Service Bulletin

R1711

Model Year 2017 Retrofit – DEF Air Filter

Peterbilt has determined that certain vehicles equipped with pre-production parts on PACCAR MX-11 and MX-13 GHG2017 MY2017 engines and built between 12/01/2015 and 10/25/2016 must be updated to production levels. R1711 involves replacing pre-production DEF tank air filter with production parts.

Figure 1 M86-6221 tank air filter location

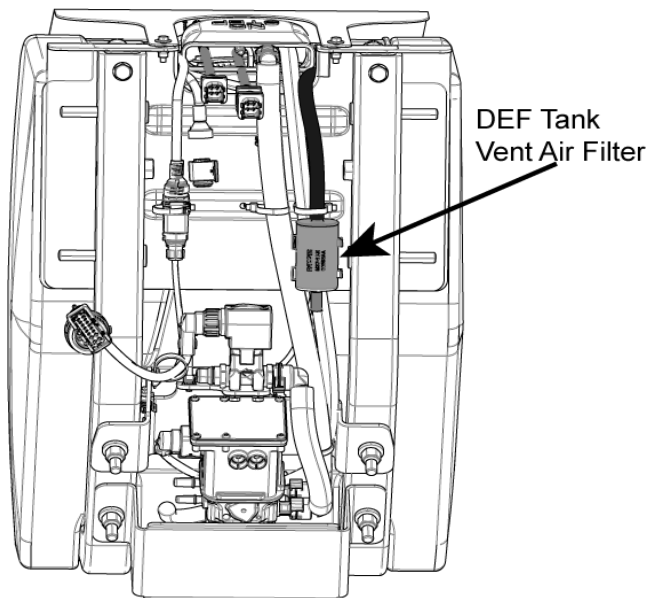
1. Use Web ECAT to identify the DEF tank assembly part number installed on the chassis, and then use the following images below to install the DEF Tank Air Vent filter in the appropriate location.
2. Secure the filter with cable ties as shown in the images. Remove the DEF tank.
